A G E N D A

Architectural Review Board

March 1, 2016

912 East Fairview Avenue

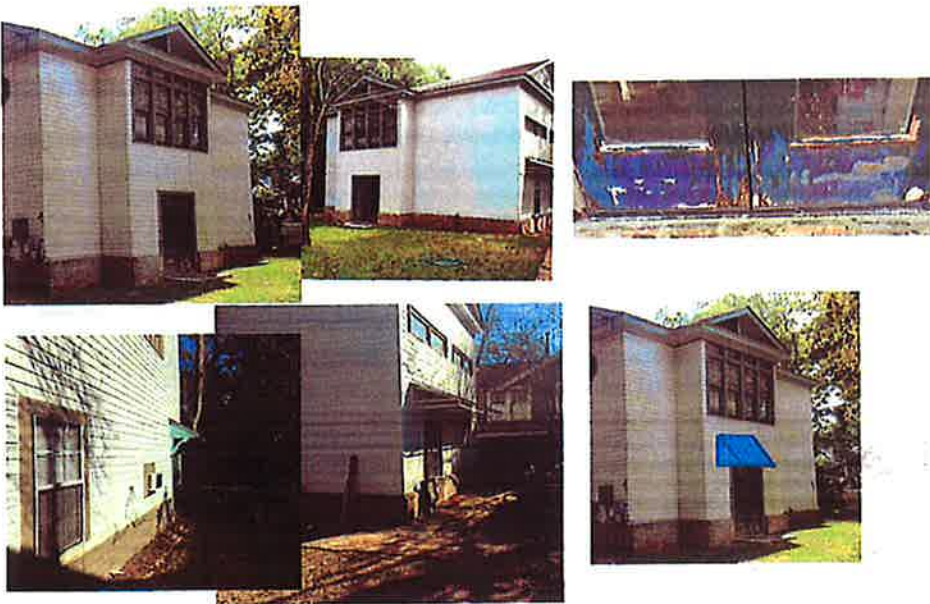
- The Board discussed the possibility of building a pergola to replace the iron structure when Mr. Riley previously appeared before the Board.

3245 LeBron Road

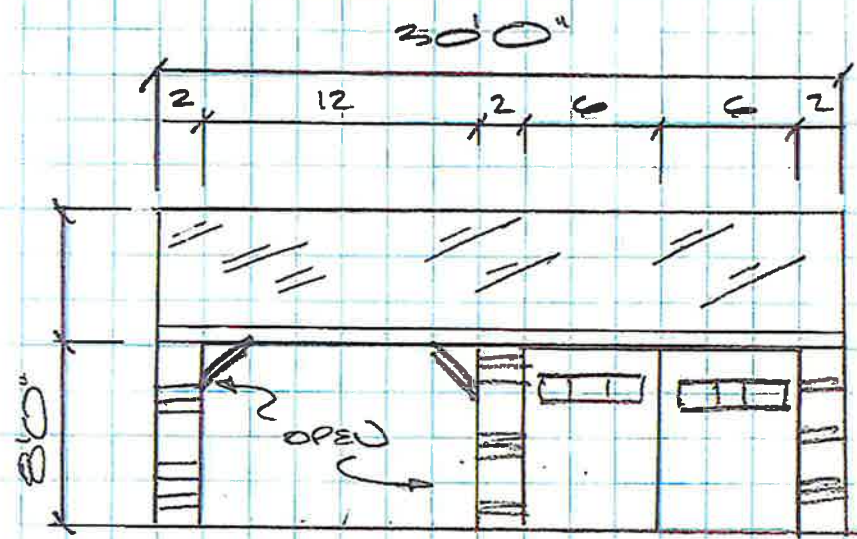
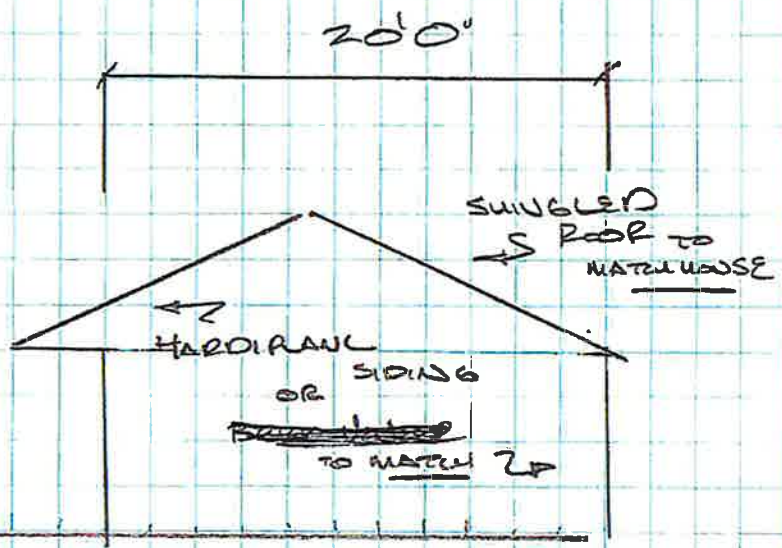
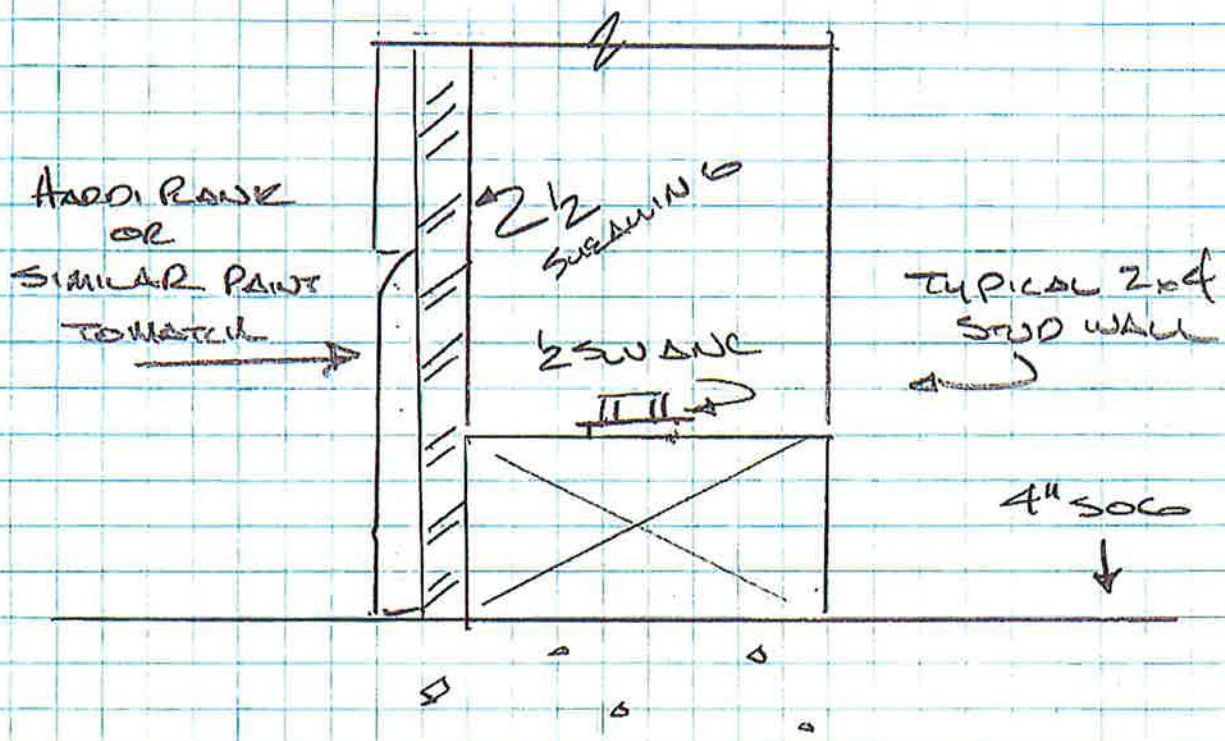
- As proposed, the use of lap siding with an overhanging eave is compatible with the historic district.
- The Board has approved garages and carports that were compatible; this is a combination of the two.

122 Commerce Street, Coosa and Bibb Street elevations

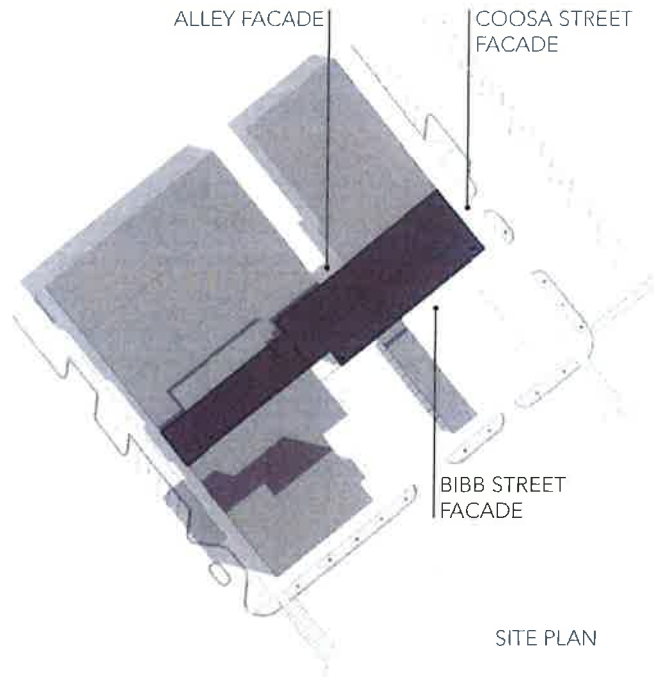
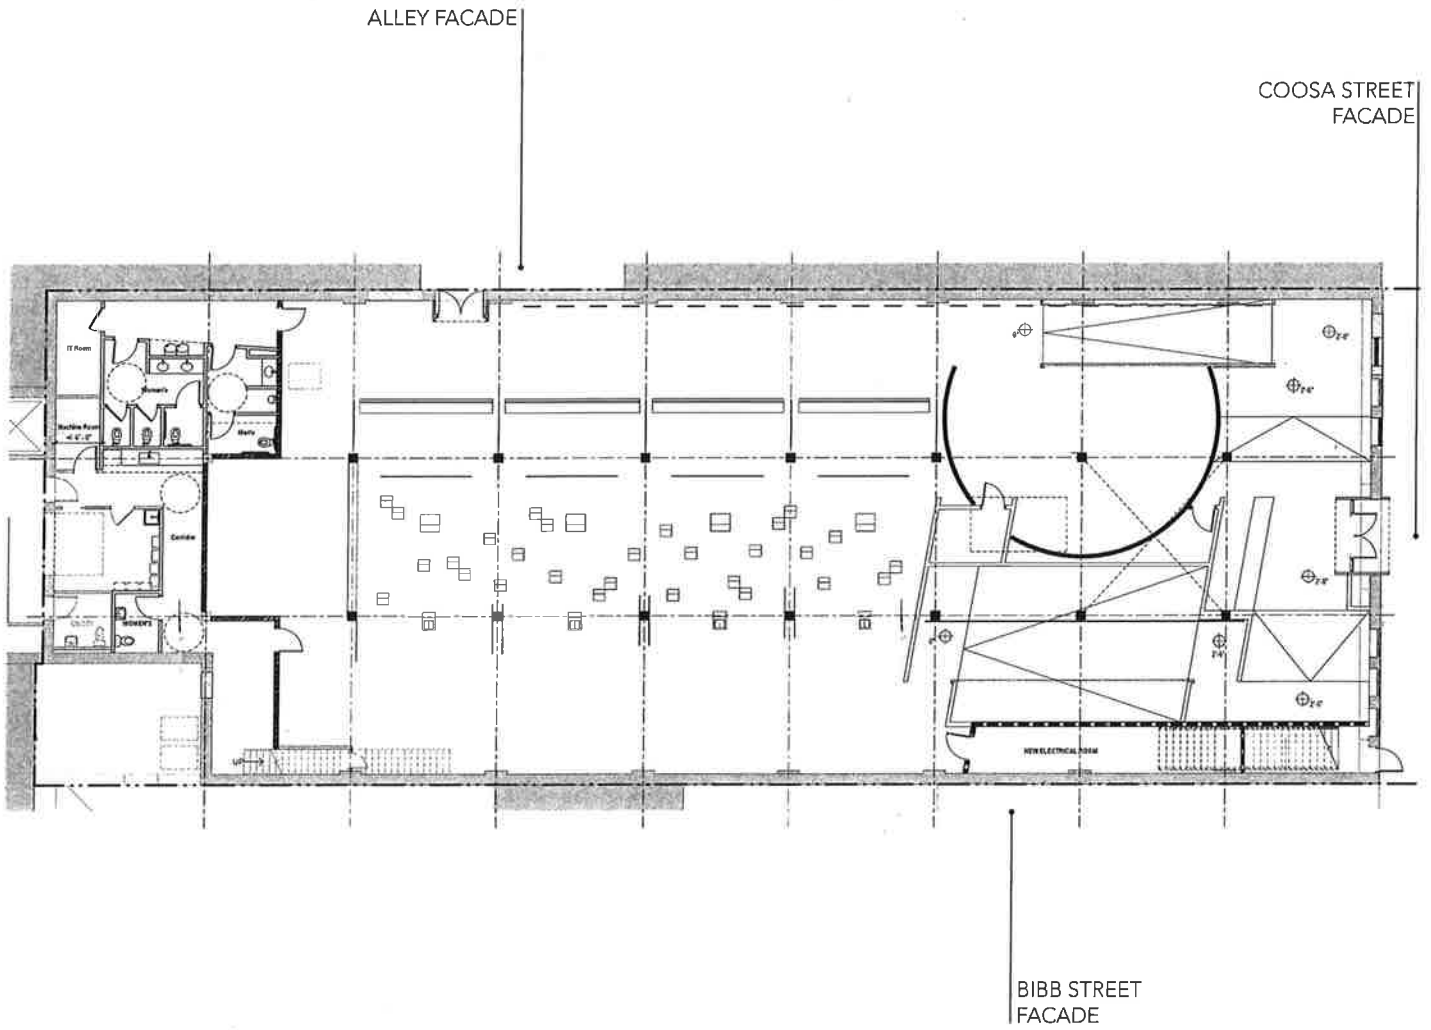
- The Board needs to determine if the proposed art installations are appropriate for a commercial historic district. SmartCode permits public art in T5 zoning.

1545 South Perry Street

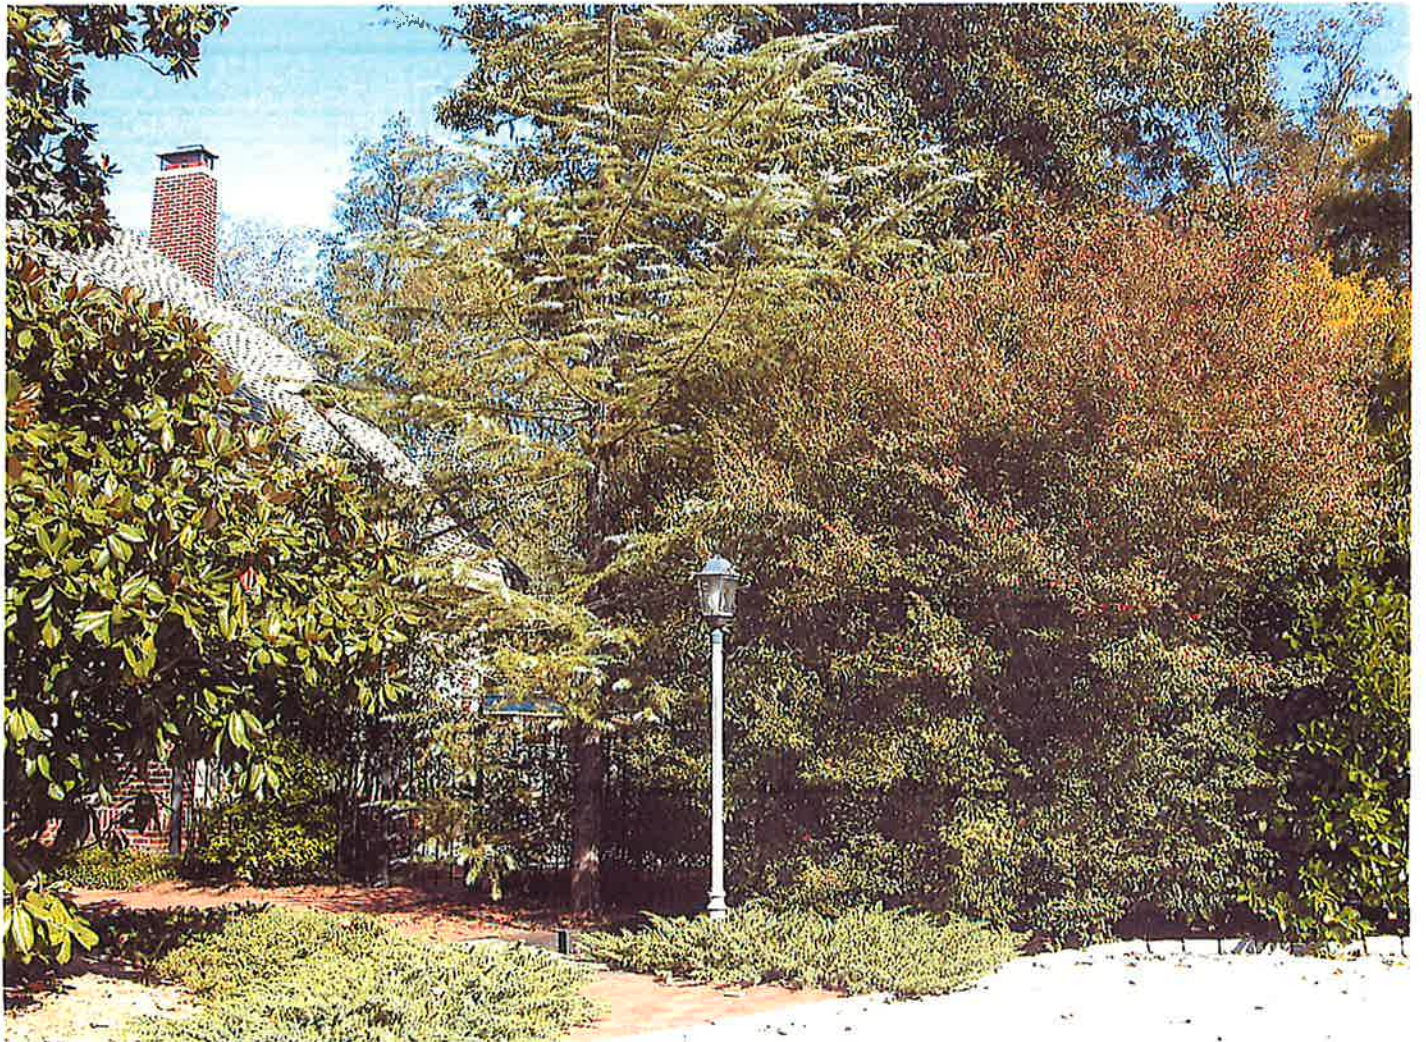
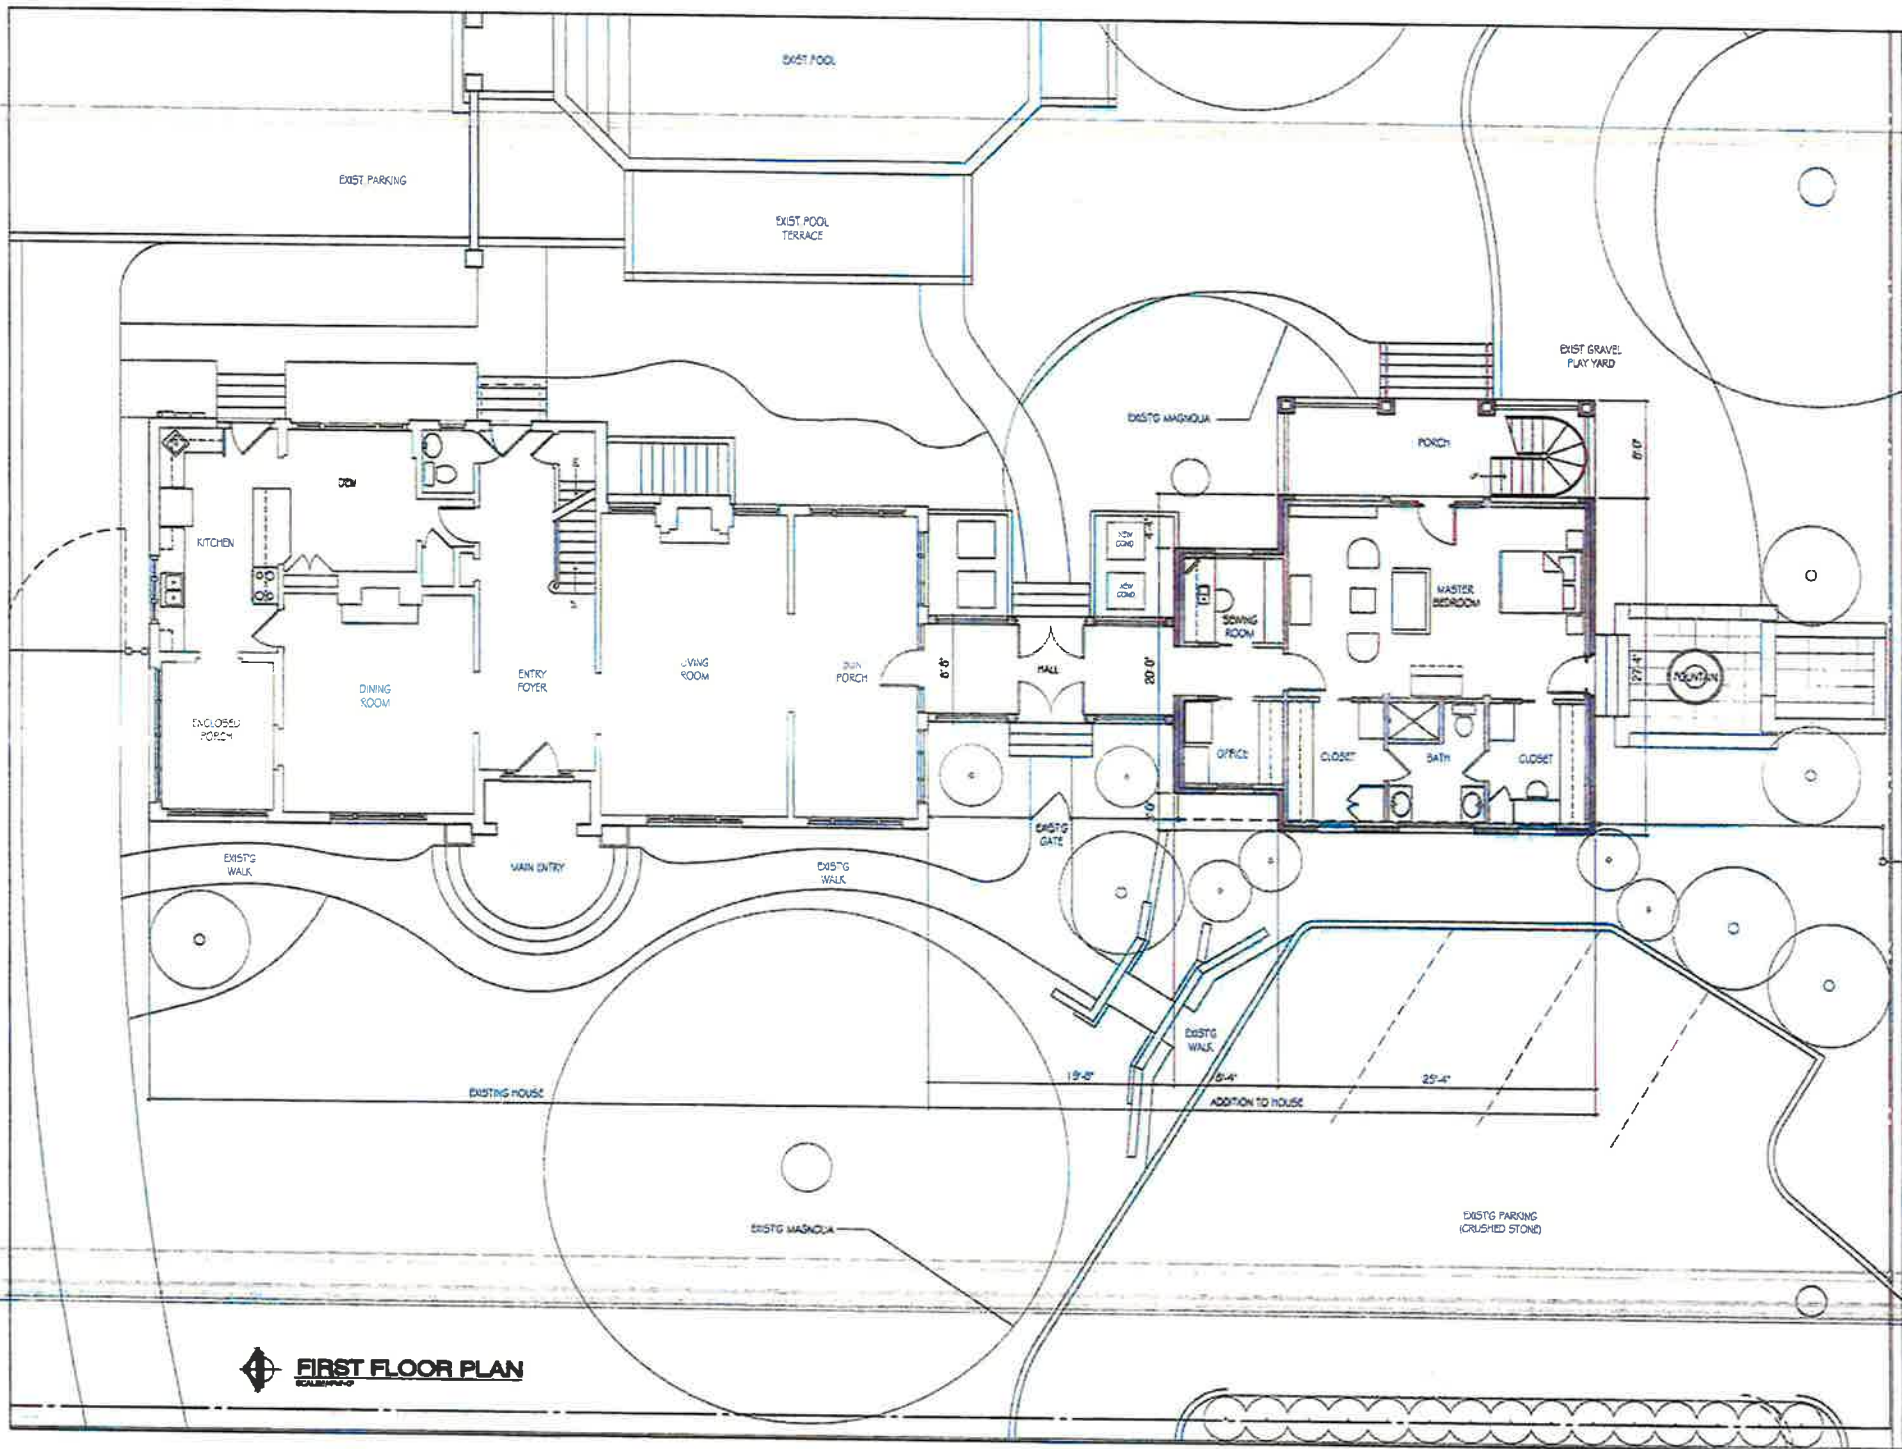
- The tree to be removed is large, healthy, and a significant part of the property.
- If removal is allowed, a large magnolia would be more appropriate for replacement.
- Plans are inserted into the agenda packet separately on 11x17 paper, the previously approved plan is attached.
